BID ADDENDUM NO. 3

OWNER: EDGEMONT UNION FREE SCHOOL DISTRICT

PROJECT NAME: ADMINISTRATION BUILDING ADDITION,
SITE IMPROVEMENTS & RELATED WORK

DATE: March 21, 2025

03-20-2025	ADDENDUM #3
03-18-2025	ADDENDUM #2
03-12-2025	ADDENDUM #1
02-28-2025	BID SET
06-10-2022	S.E.D. SUBMISSION
DATE	ISSUED TO
SHEET SIZE 30"x42"	DRAWING NO. AD E200
SCALE AS NOTED	FILE NO. 24529.02
DRAWN BY LFG

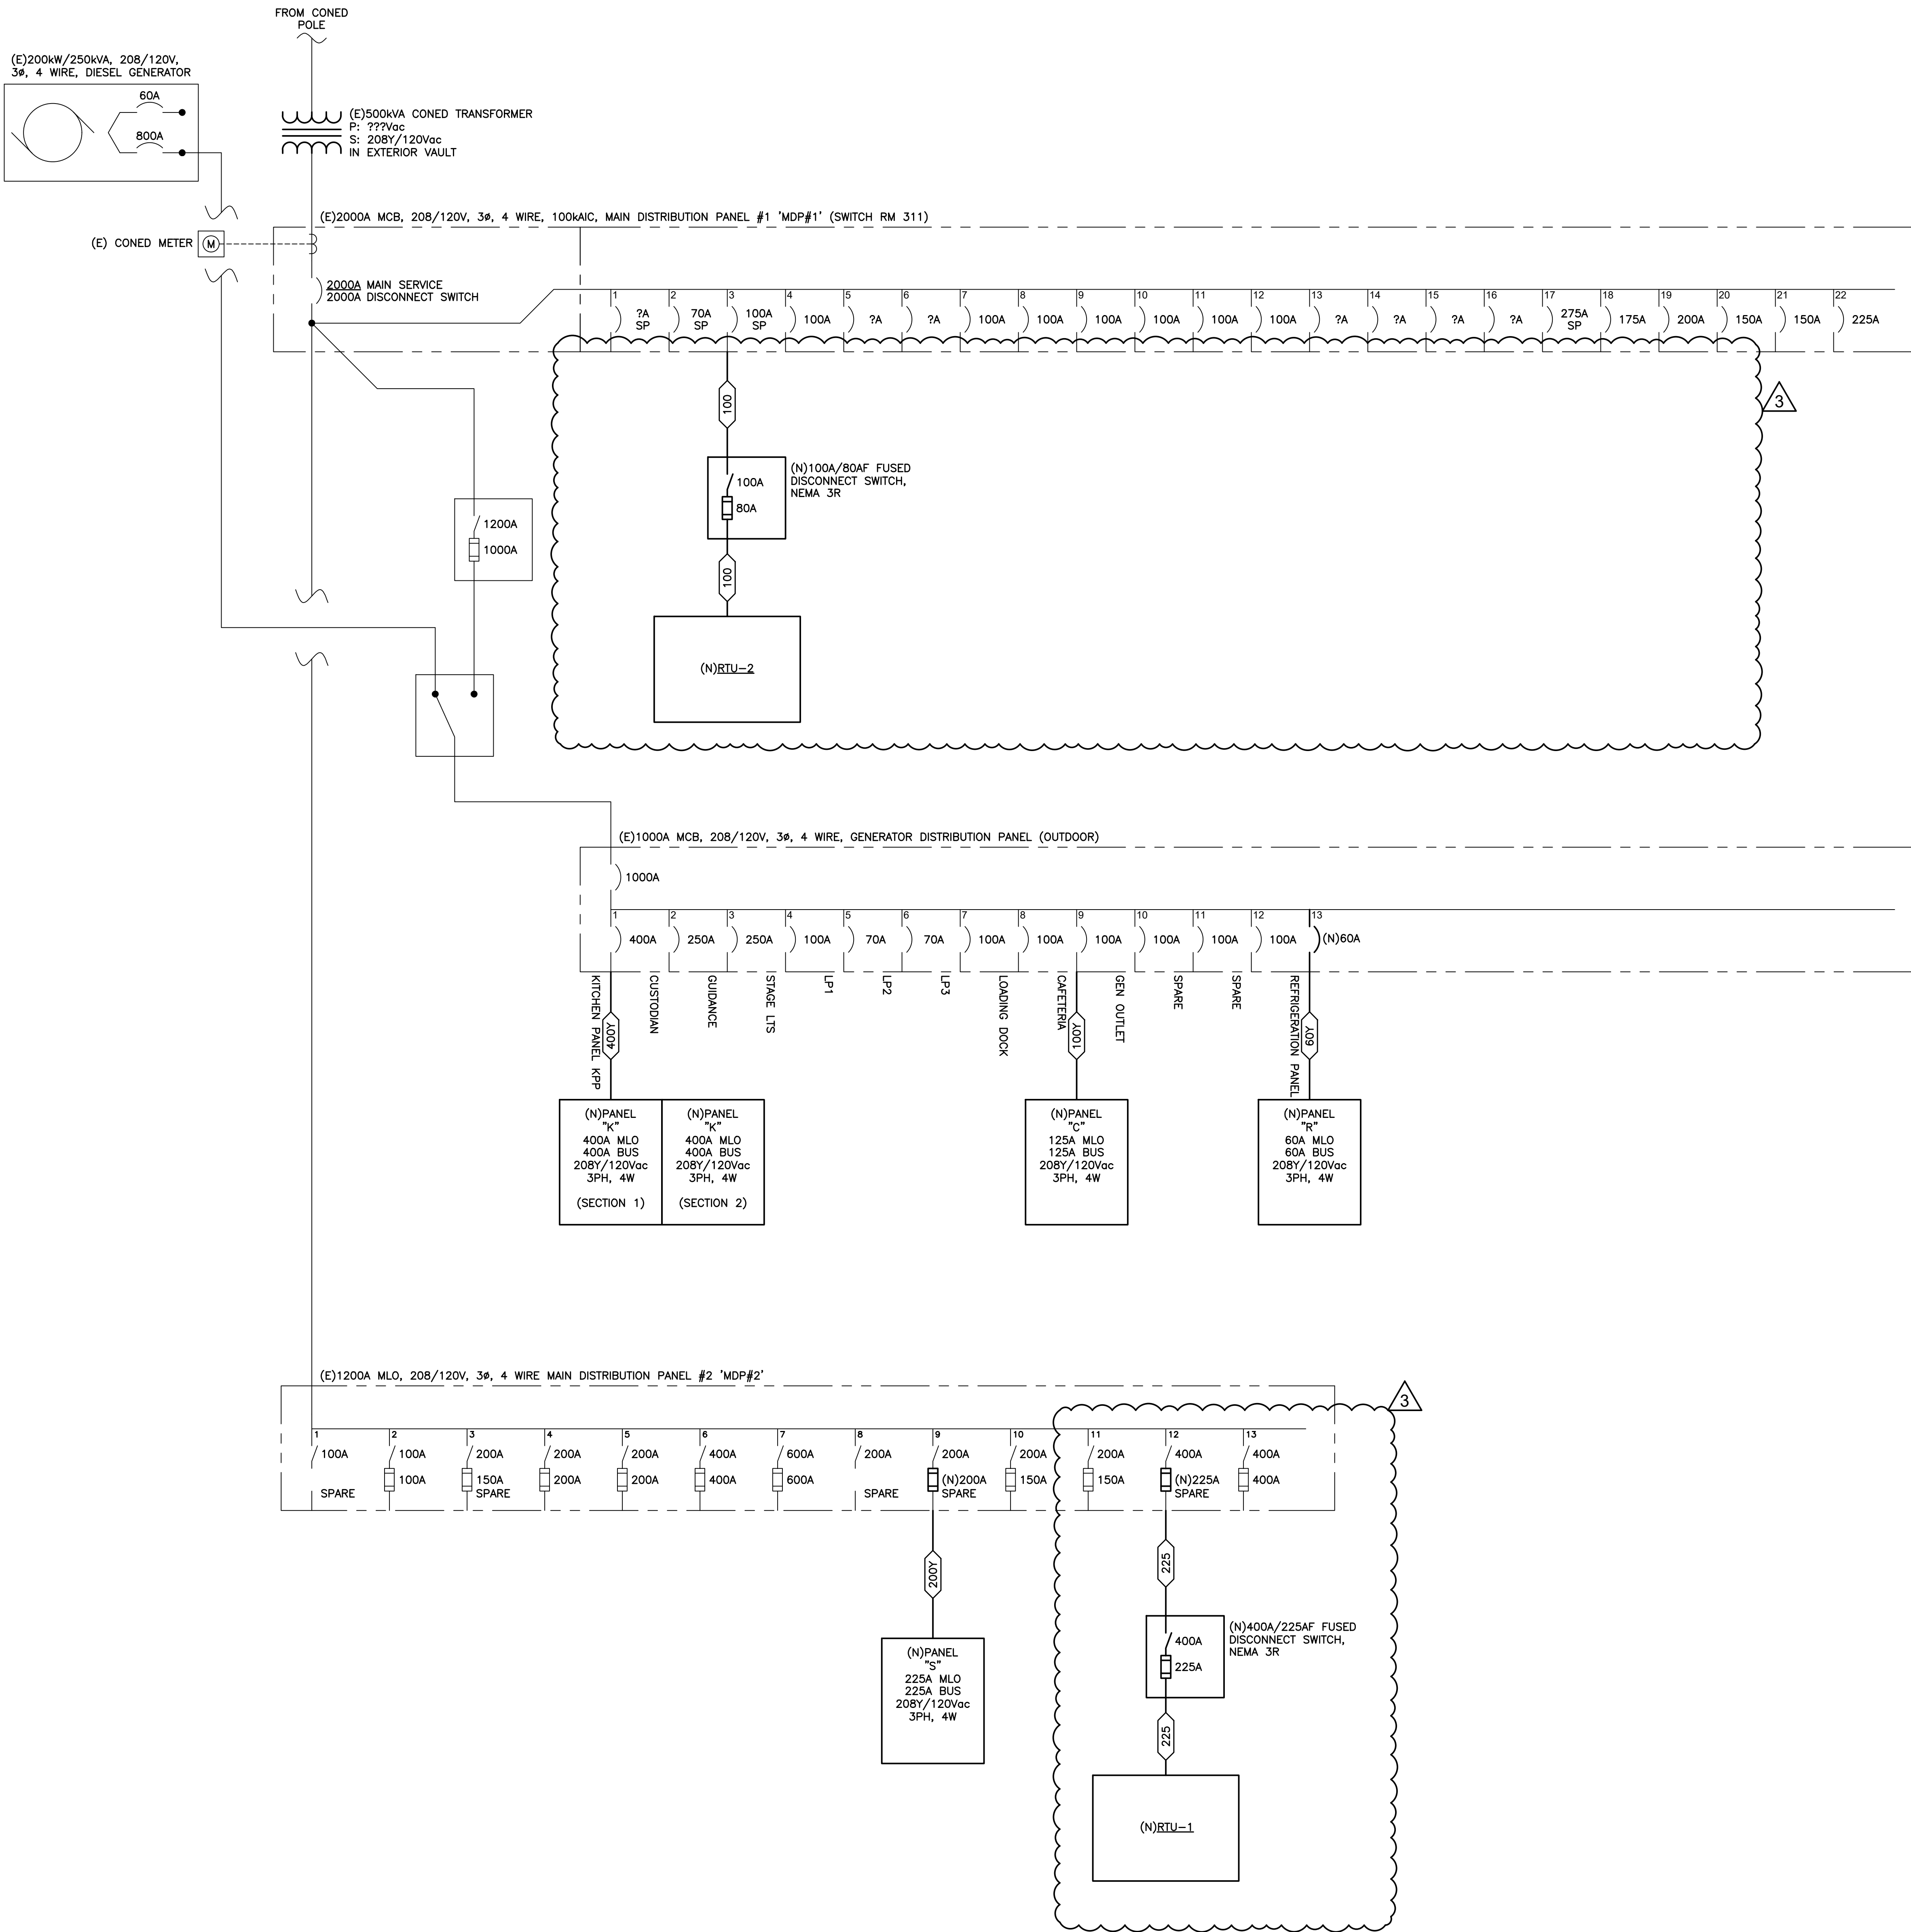
DRAWING AD E200 – ELECTRICAL ONE LINE DIAGRAM

REVISE one line diagram as shown on revised drawing attached to this addendum.

DRAWING NO.
A200

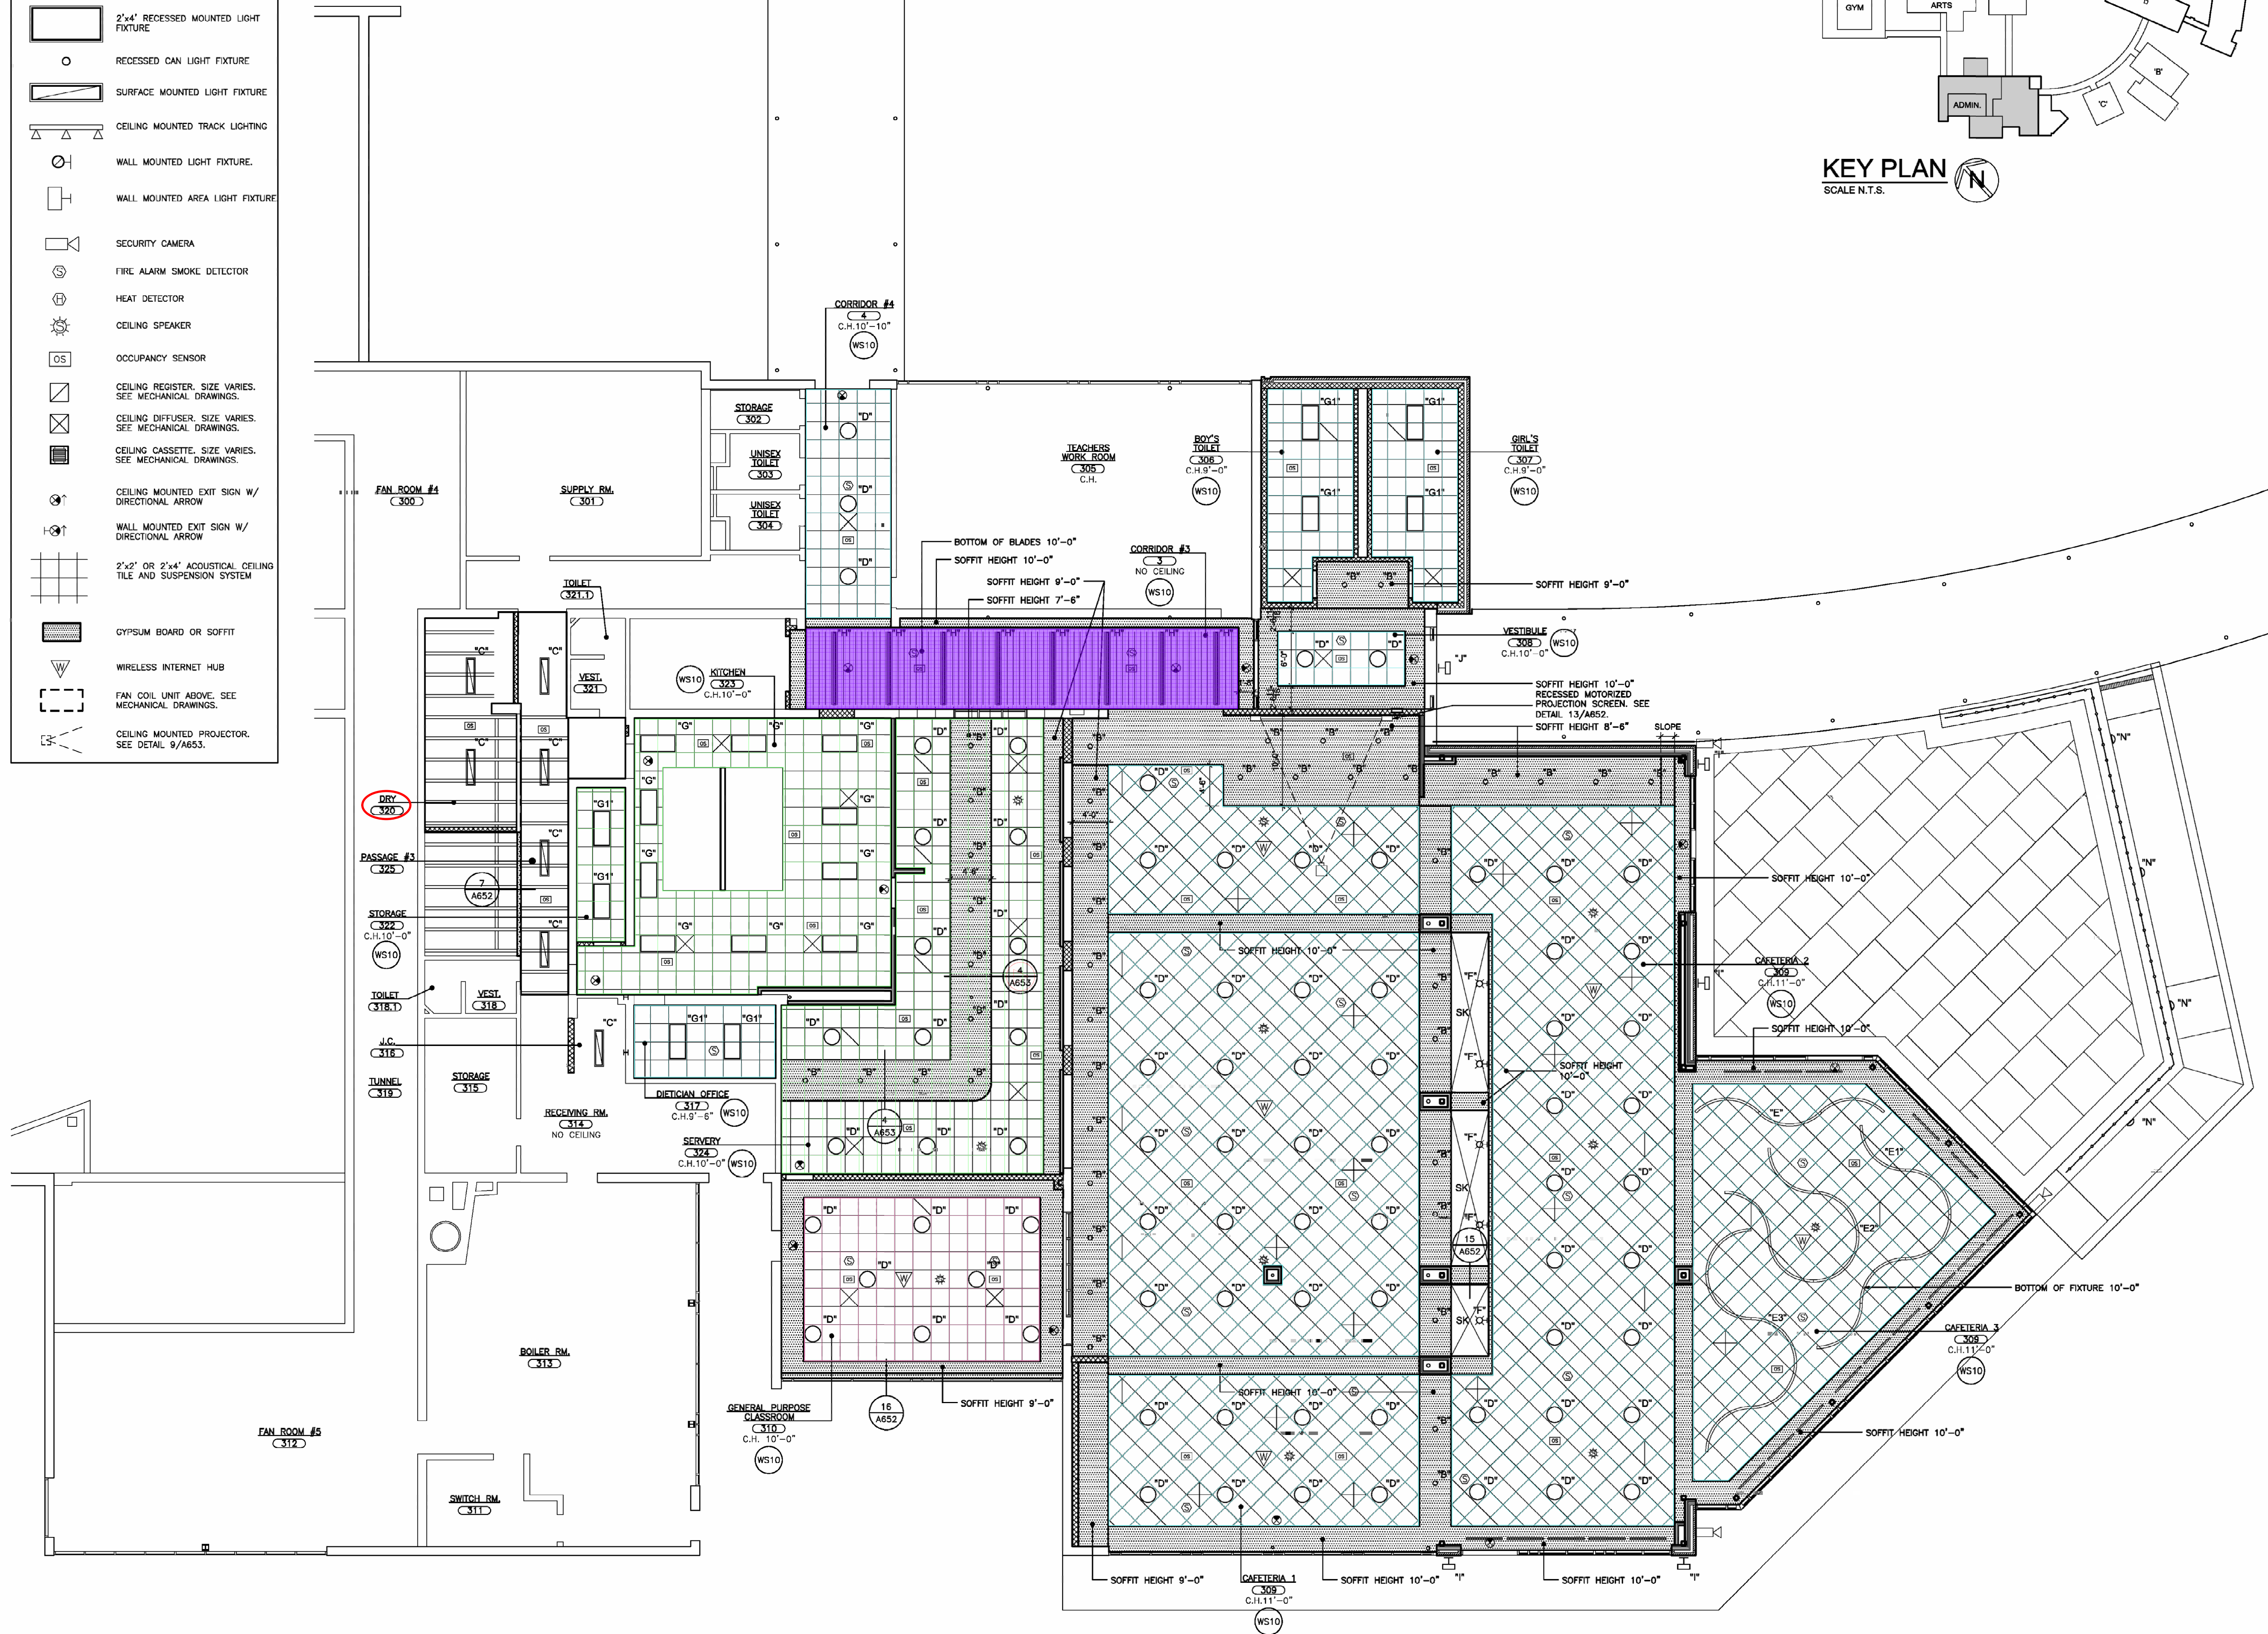
QUESTION: Classroom 310: Finish Schedule lists ACT-2, but the Legend indicates ACT-1 in Classrooms
